SAFER Bay Project

ECRB Meeting 10/23/2026

Geotechnical and Geology Issues

- Sta 280+00

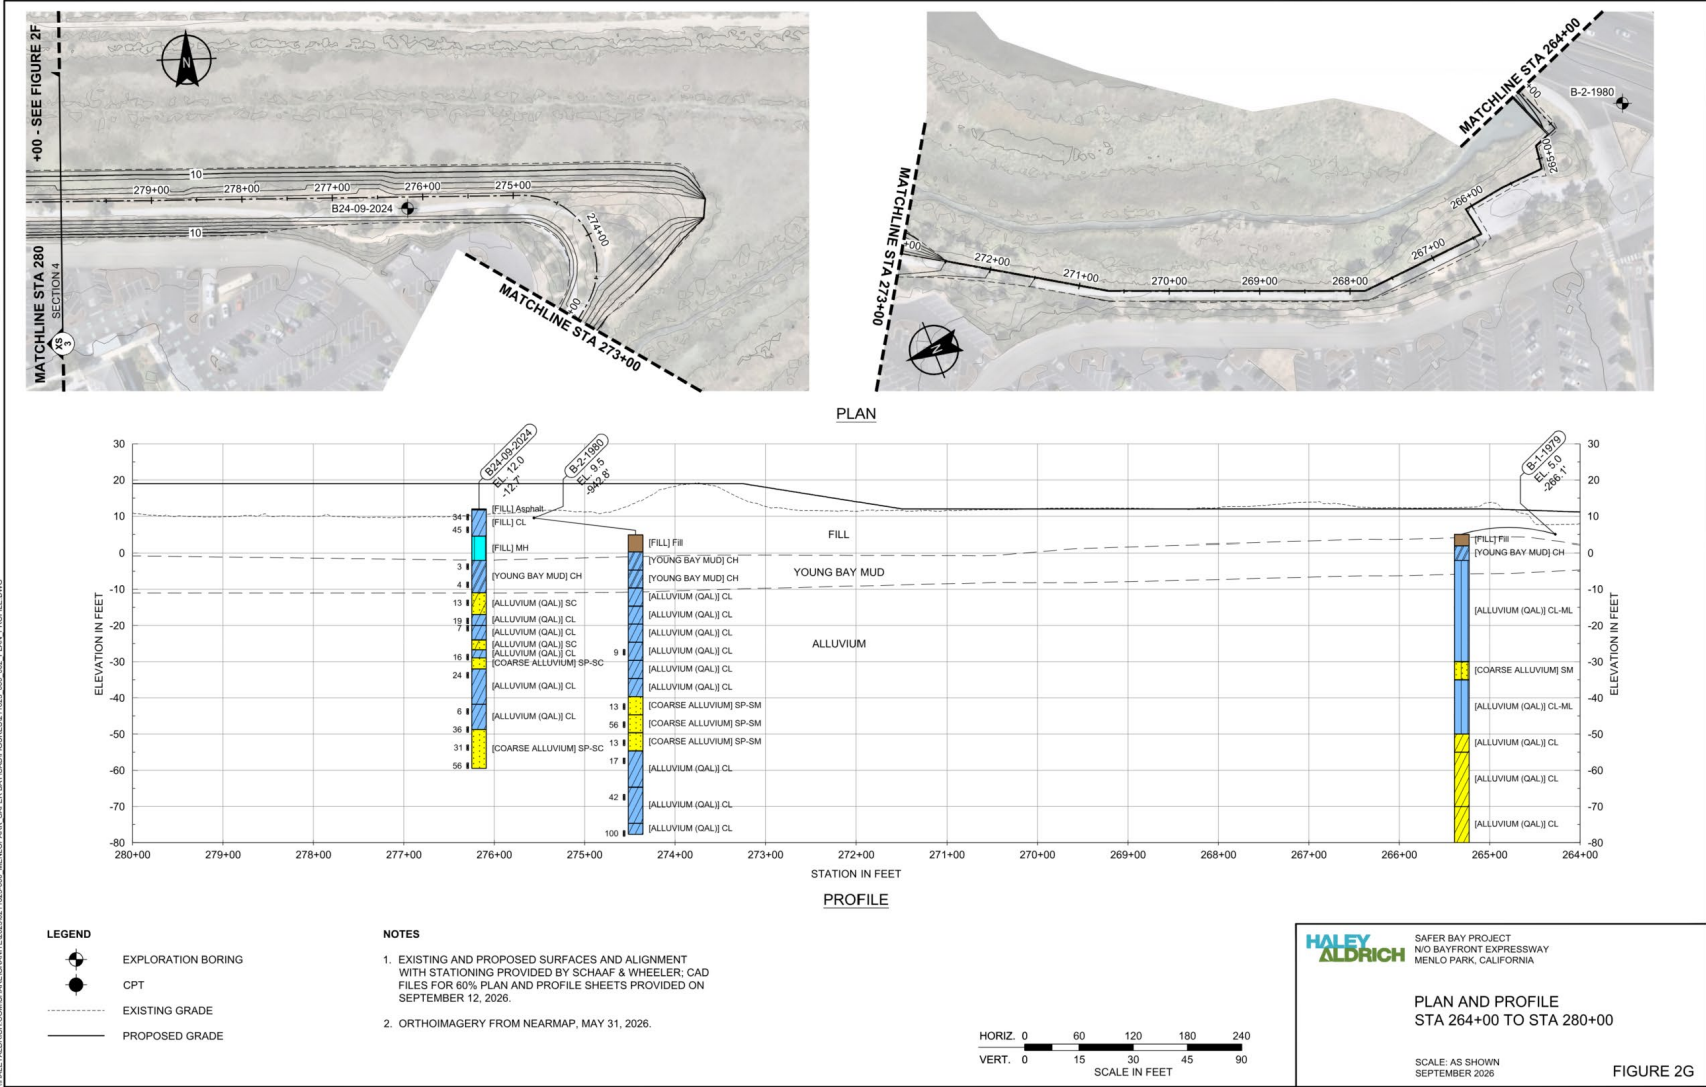
- ECRB Comment: The ECRB requested that a longitudinal geological profile for the Menlo Park project reaches under review be provided to the ECRB. BCDC staff recommends that this documentation be provided in the form of an updated Basis of Design report.
- The next series of slides are longitudinal profiles at our analysis cross sections. Profiles for the full Menlo Park alignment are in our draft BOD. As noted previously, four typical sections at Project Stations 217+00, 245+00, 280+00, and 321+00, and representing each of the three project reaches, were selected for analysis based on height of new fill, thickness of Bay Mud, and the presence of significant sand layers.

Additional Loading Scenario

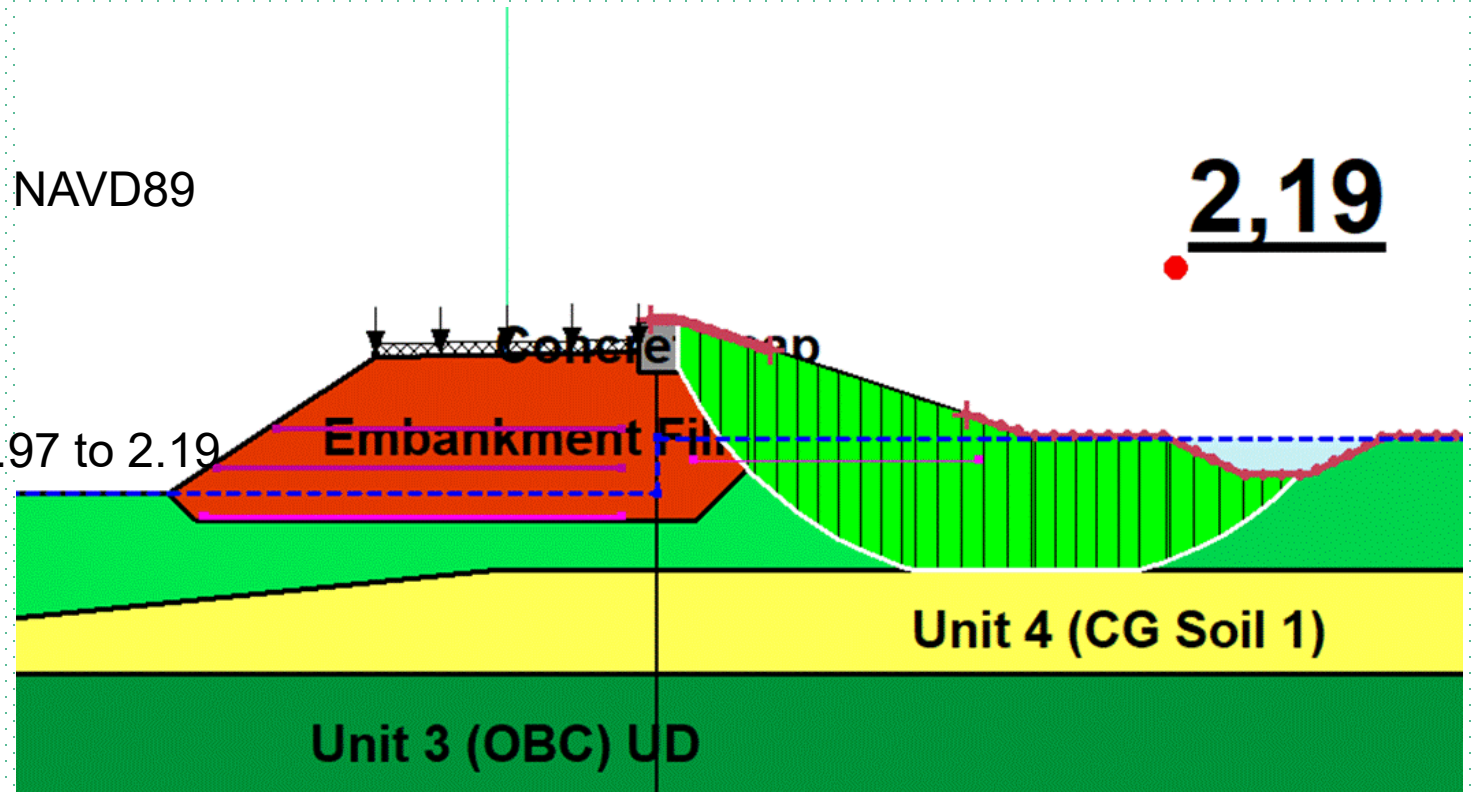
- ECRB Comment: For both the slope stability analysis and sheet pile wall design, the ECRB required that a more conservative combined loading scenario be evaluated: low tide on the Bayside paired with a high groundwater table on the landside. BCDC staff recommends that documentation of this additional analysis be provided in the form of an updated Basis of Design report.

- Additional slope stability analysis was performed consisting of low water conditions on the bayside and a high groundwater table on the landside.
- Groundwater levels
 - Landside = ground surface
 - Waterside water level = 7.3 ft NAVD89
- Factor of Safety
 - Landside = no change
 - Waterside = increased from 1.97 to 2.19

Seismic Instrumentation

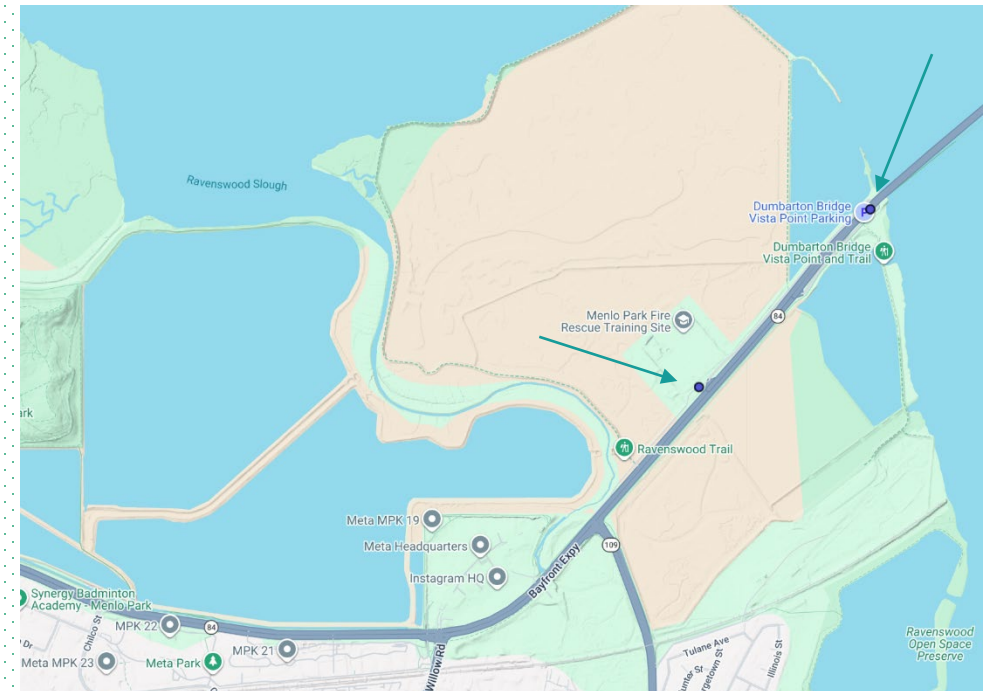
- ECRB Comment: The ECRB requested that the project team consider coordinating with the California Geological Survey to install seismometers at the project site.
- Response: The project team has begun this coordination. Determination of installing a seismometer will consider installation and maintenance cost, locations available within the project site, and availability of nearby seismometers already within the CGS network. There are currently 2 installations in the immediate Menlo Park vicinity.

Interpreting the current ACS1 results

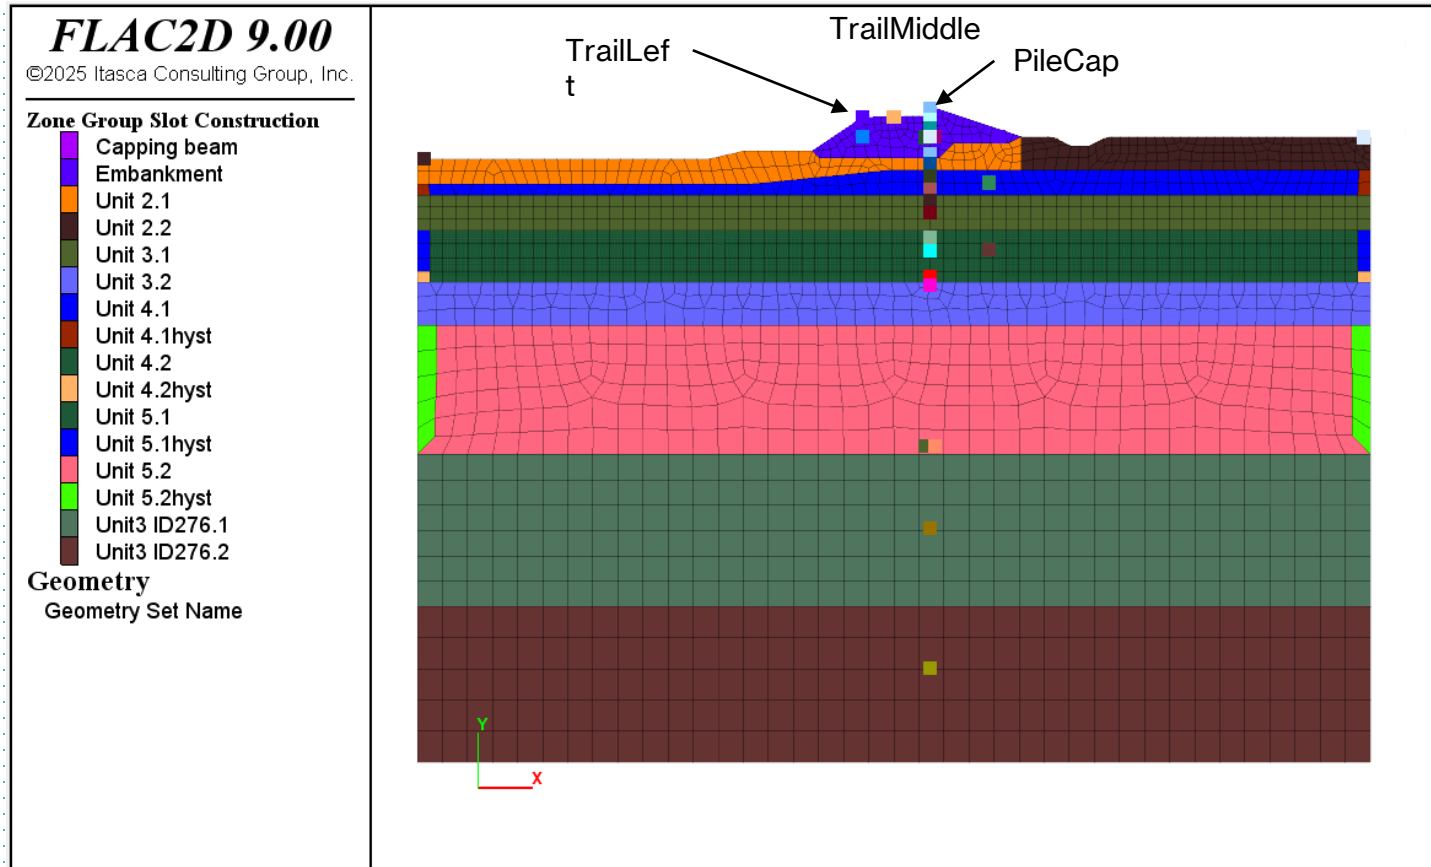
- ECRB Comment: The ECRB requested to review the outputs of the project's ongoing seismic analysis, including FLAC modeling results. BCDC staff recommends that this documentation be provided in the form of an updated Basis of Design report.
- Haley & Aldrich are just beginning this work and are unable to present anything at this time.
 - BOD has results from pseudo-static evaluations.

- Average minimum trail settlement across the seven motions is 2.7 ft.
- TH2 worst: 3.1 ft minimum trail settlement; its cross-section average is 3.5 ft and pile-cap settlement is 4.0 ft.

The current ACS1 crest-settlement metric is within the 3.4 ft MDE criterion. The plots do not establish OBE performance or confirm post-seismic hydraulic-barrier and sheet-pile structural acceptability.

Revised Wave Modeling and Wave Runup

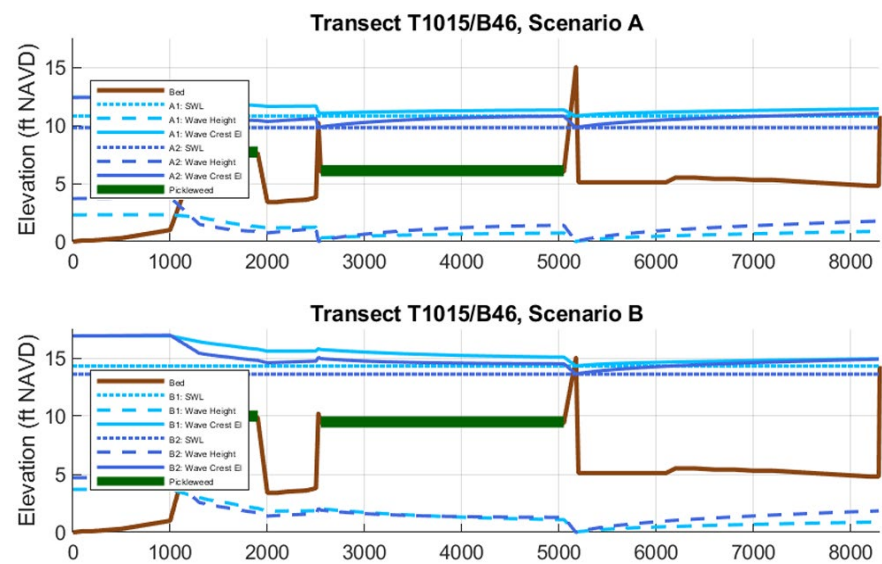
- ECRB Comment: The ECRB requested that the updated analysis presented at the meeting be provided as part of an updated ESA Coastal Wave Runup Study, including documentation of how this study was integrated with the FlowWest Coastal Hydraulics Study.

ESA's coastal hazard analysis has been updated to reflect revised wave modeling and wave runup calculations for the transects crossing Pond R3 and Pond R4. This includes updating the elevation of the berm crest between Pond R3 and R4 to its design elevation of 15 ft NAVD.

Marsh Accretion Study

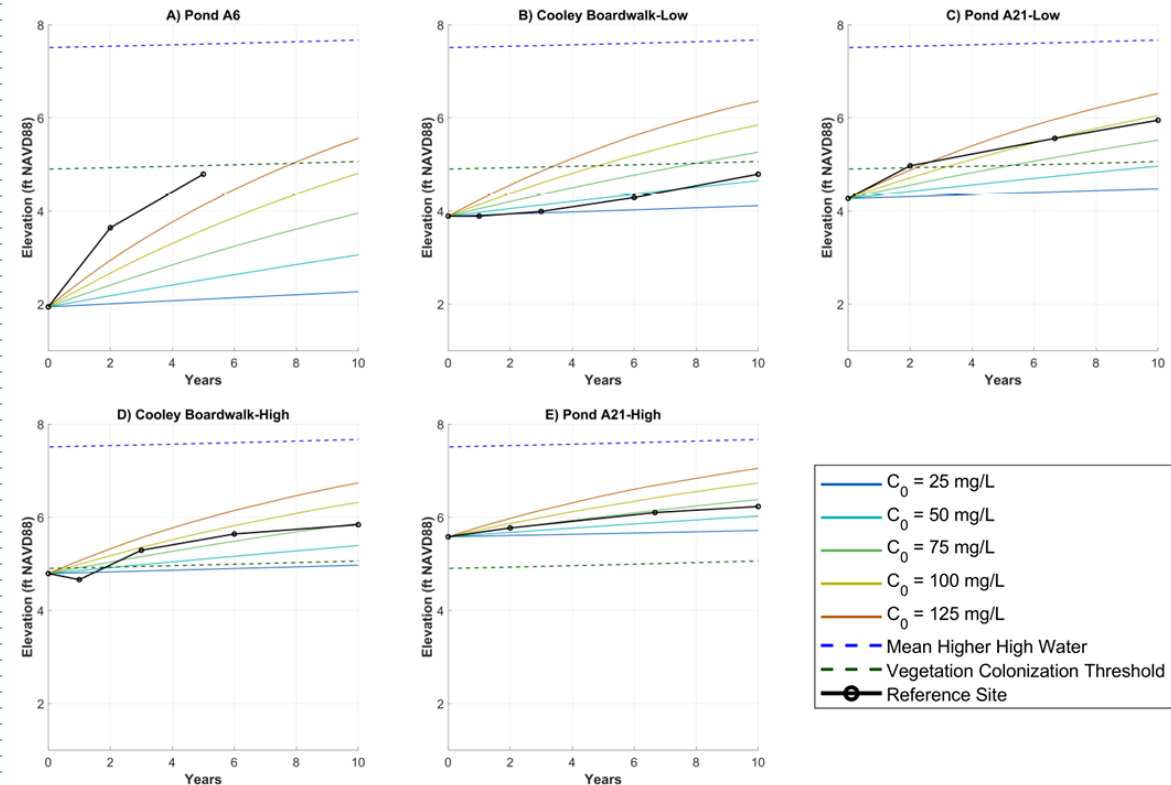
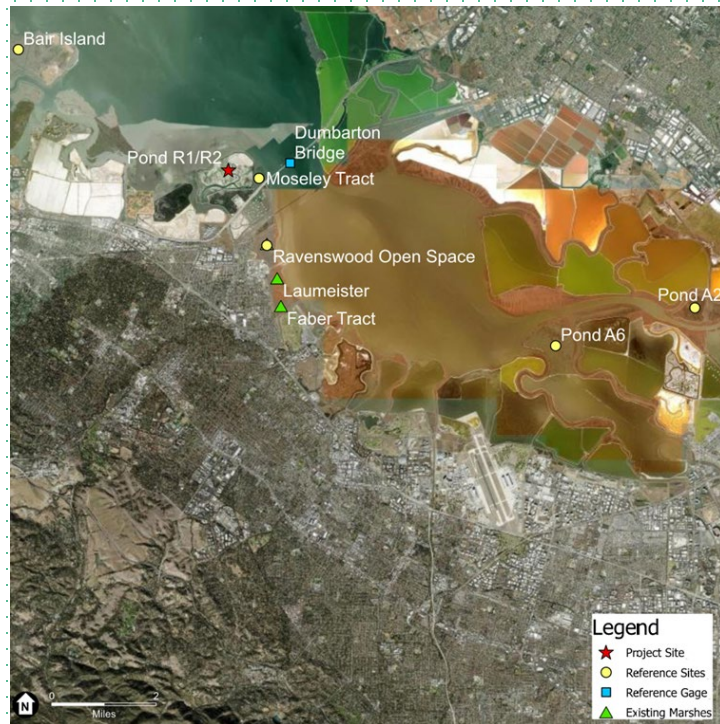
- ECRB Comment: The ECRB requested that the marsh accretion modeling underlying the coastal study's marsh accretion rate assumptions is provided to the ECRB.

Details of the marsh accretion modeling are provided in H.T. Harvey et al. (2026) Appendix A. Accretion rates from nearby reference sites were used to calibrate the accretion modeling.
